Group of Experts on Permanent Identification of Railway Rolling Stock

**Development of the permanent marking on  
the Unique Rail Vehicle Identification System:  
Development of the framework**

### **Comparison of revised model rules with ECE/TRANS/SC.2/PIRRS/2021/8**

**Submitted by the Rail Working Group**

Visualisation (Option 1):

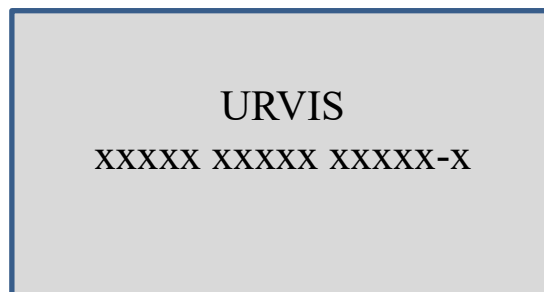
[Option 1: the URVIS identifier only, i.e. “URVIS identifier: xxxxxxxxxxxxxxxx-x”]

[the URVIS identifier “URVIS identifierxxxxx  
xxxxx xxxxx-x”]

Visualisation (Option 2):

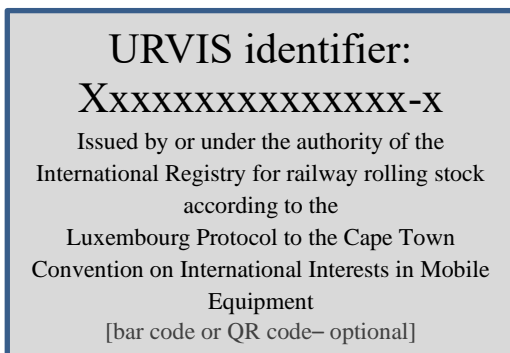
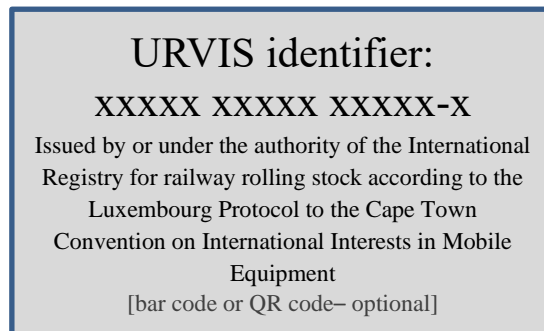
**Option 2:** URVIS identifier and detailed marking in English language, which includes:

- Clarification text, e.g. “Issued by or under the authority of the International Registry for railway rolling stock according to the Luxembourg Protocol to the Cape Town Convention on International Interests in Mobile Equipment”
- Optional: Manufacturer’s Name, Serial Number, Other information

**Option 1:** URVIS identifier and detailed marking in English language, which includes:

- Clarification text, e.g. “Issued by or under the authority of the International Registry for railway rolling stock according to the Luxembourg Protocol to the Cape Town Convention on International Interests in Mobile Equipment”
- Optional: Manufacturer’s Name, Serial Number, Other information
